TOWN OF FRANKLIN – OBSERVATION REPORT

725 Union Street

Report No.:	4831 723 - 33	Date:	March 6 & 18, 2024	Arrive:	N/A
Observer:	Matt Crowley, PE	Weather:	N/A	Leave:	N/A
Owner:	725 Union Street LLC 153 Buckskin Drive Weston, MA 02493	Engineer:	J.K. Holmgren Engineering Inc. 1024 Pearl Street Brockton, MA 02301

Items Observed: **Conformance Observation – Submitted in conjunction with
Applicant’s request for acceptance of Form H – Certificate of Completion**

Former striped crosswalk, blacked out

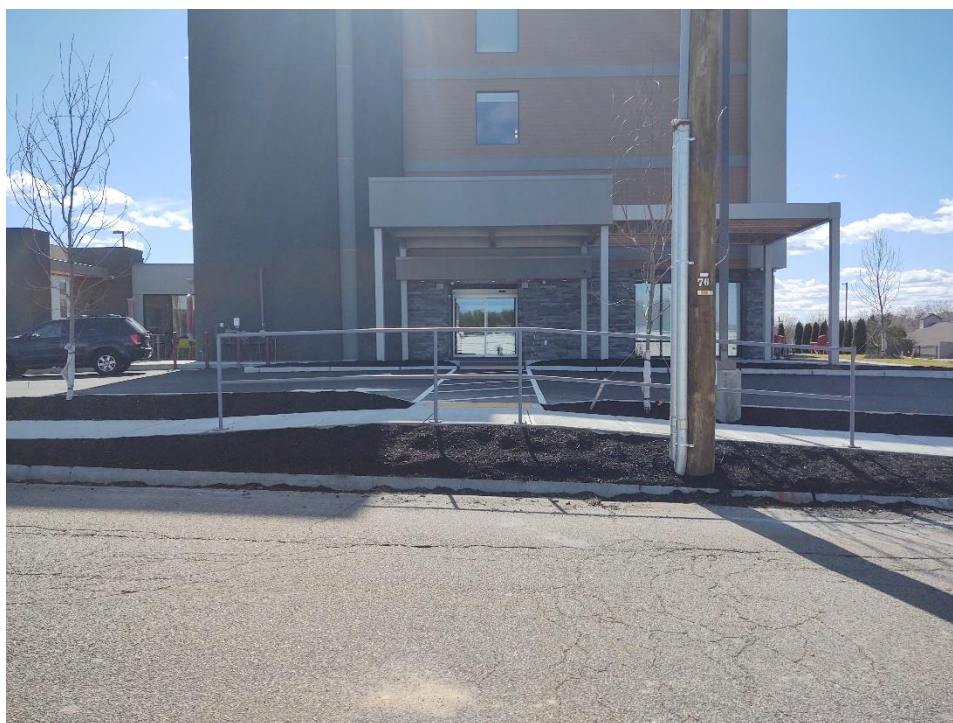
- The previously installed detectable warning and striped crosswalk from Union Street to the building sidewalk has been removed and blacked out.
- A new accessible route has been added from the front of the building to the sidewalk on Union Street. To resolve the grade differential between the site pavement and Union Street sidewalk (private), a portion of the sidewalk has been reconstructed with a grade exceeding 5%. As such, this portion of sidewalk is now considered a ramp and must have handrails installed in accordance with 521 CMR. Based on BETA’s discussion with the contractor this work is to be completed prior to the next Planning Board hearing and BETA will give a verbal update at that time.

Modified parking with additional space provided

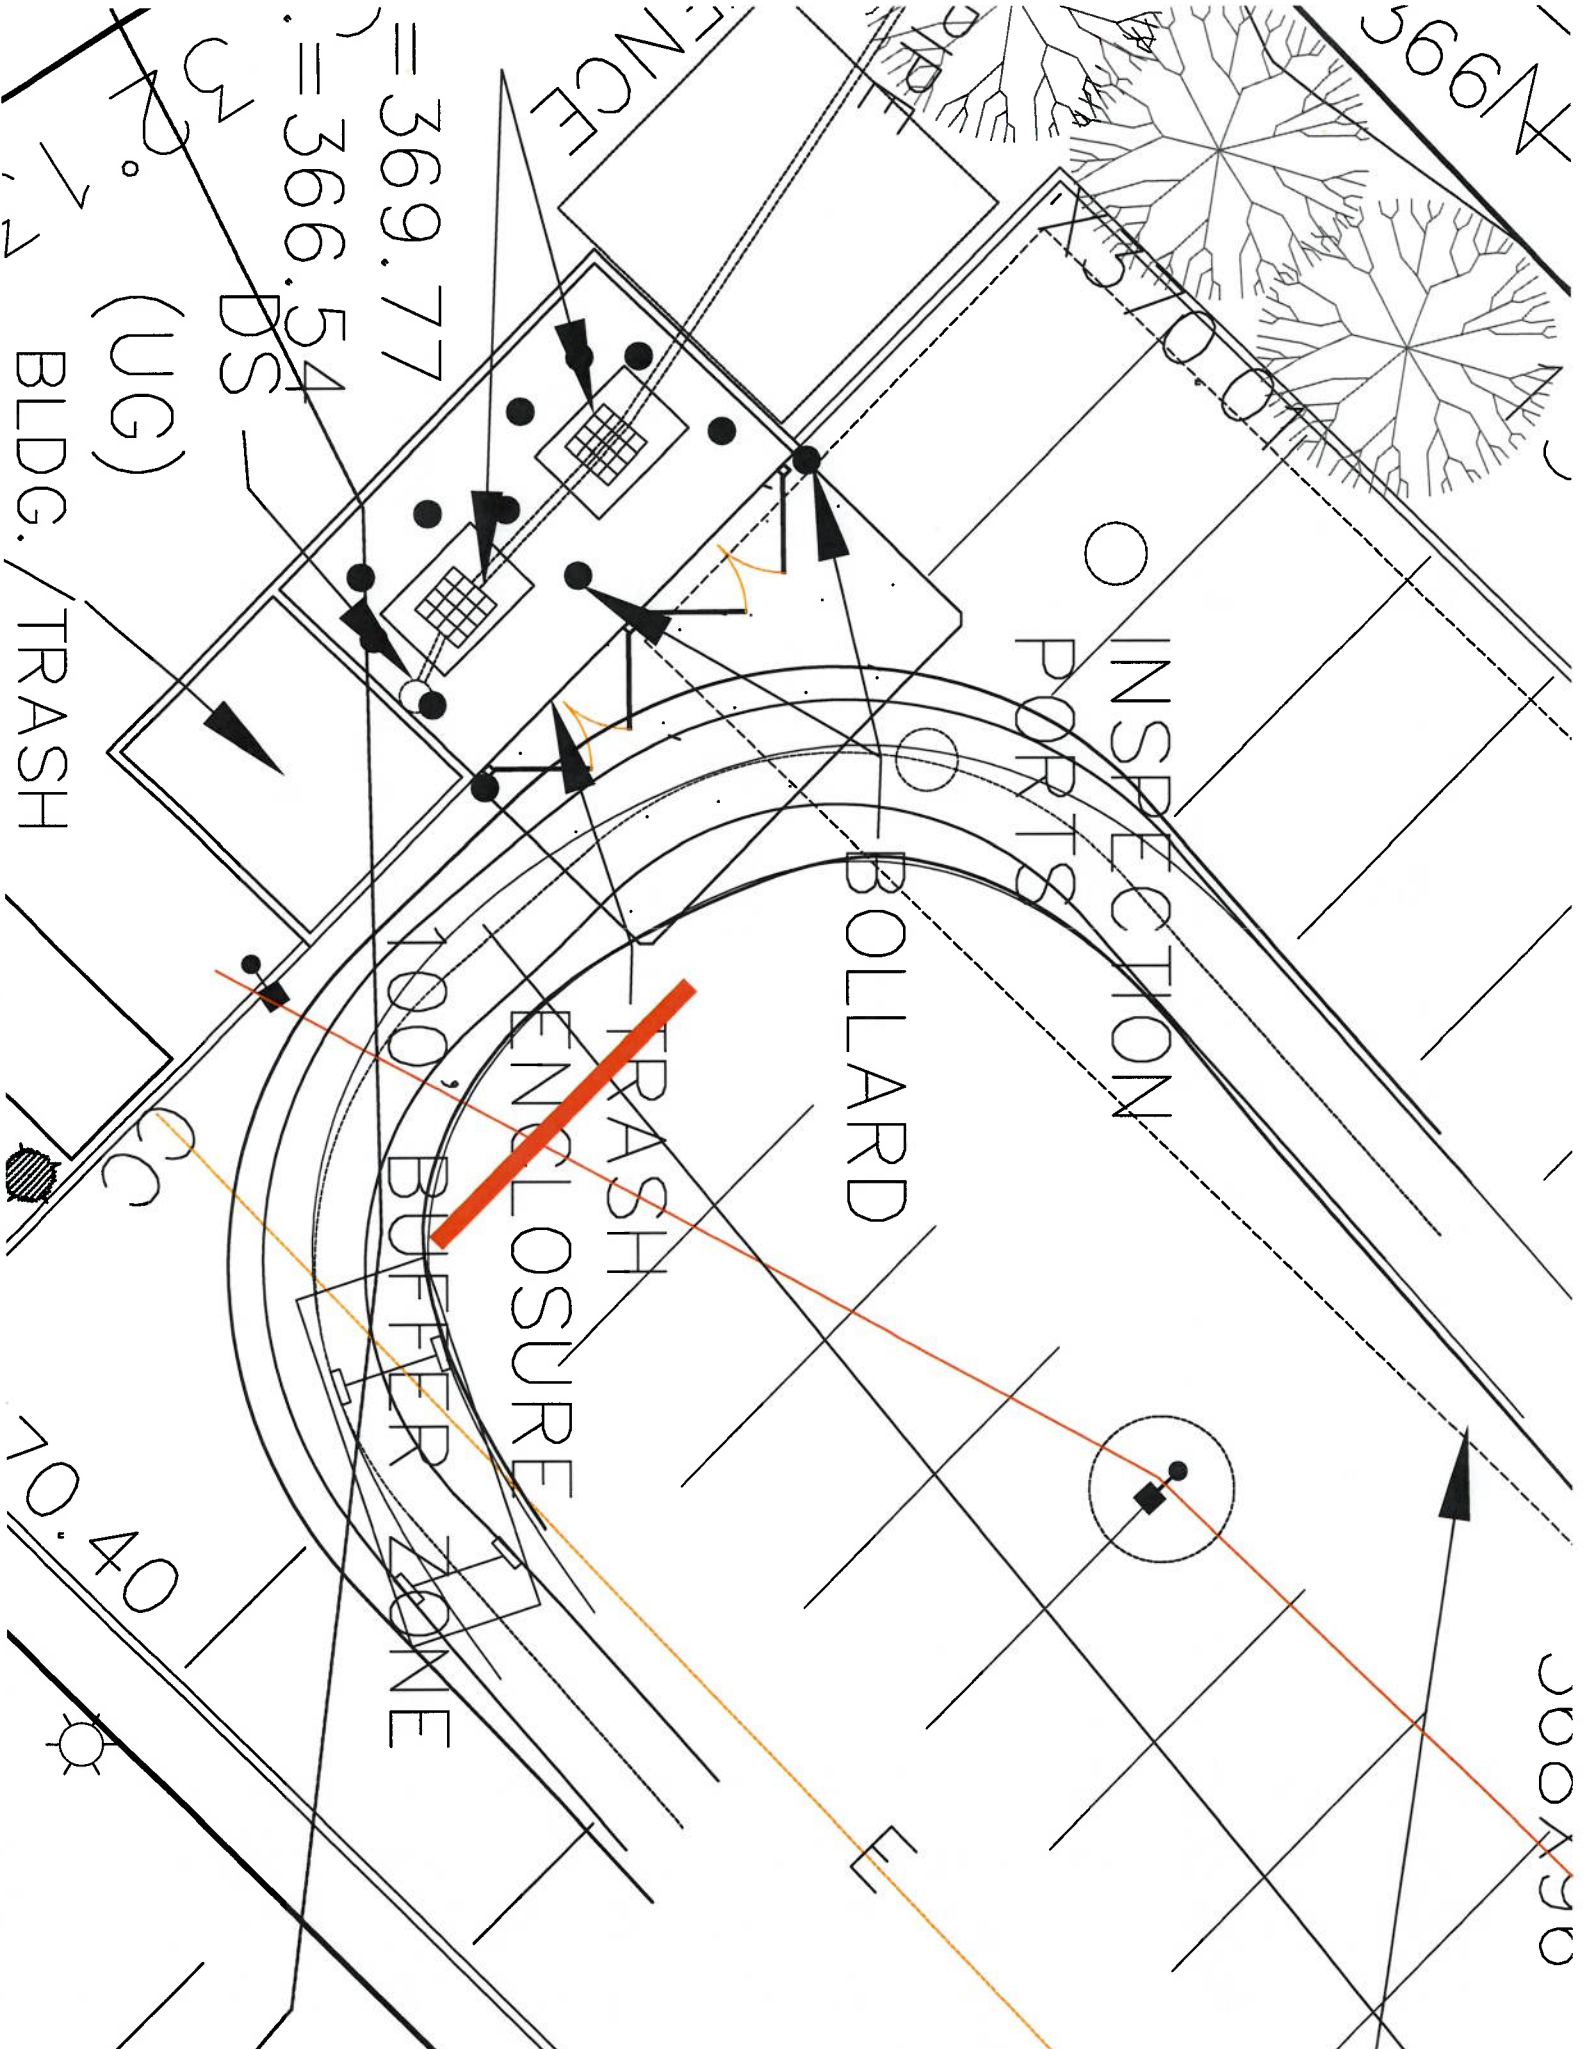
- An additional parking space has been striped near the rear of the site to meet the total of 100 on the Approved Plans. Although the parking requirement is now met, BETA notes that the new space reduces the turning radius for vehicles circulating in the area and there appears to be an encroachment into the adjacent parallel parking stall (refer to attached turning plan). BETA also notes that during the original approval process there has been discussions to permit valet parking to stack vehicles at the rear of the site on the rare occasions when the hotel was at full occupancy. BETA recommends for the Engineer of Record to provide more information to the Board on this subject.
